Technical *data*

CT 1014 K3 retrofitting kit for diverse Opel/ GM 1.7 DTI (up to engine number 328703)

Fig. 3

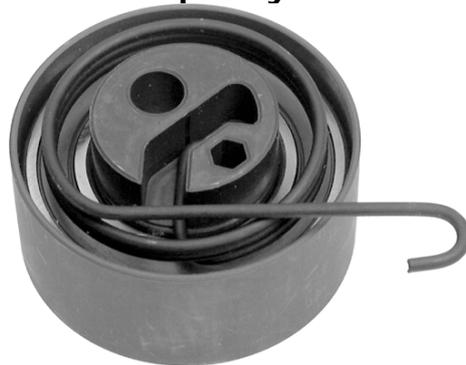
The new pulley does not fit into the slot for the old idler pulley. The engine support bracket is now positioned at a slant to the engine and can no longer be screwed onto it.

The old engine support bracket must also be replaced with the likewise enclosed new type. This is necessary because with the new pulley there is no longer any base plate, which also previously served as spacer plate for the engine retainer. Screws should be tightened to a torque of: **49 Nm**
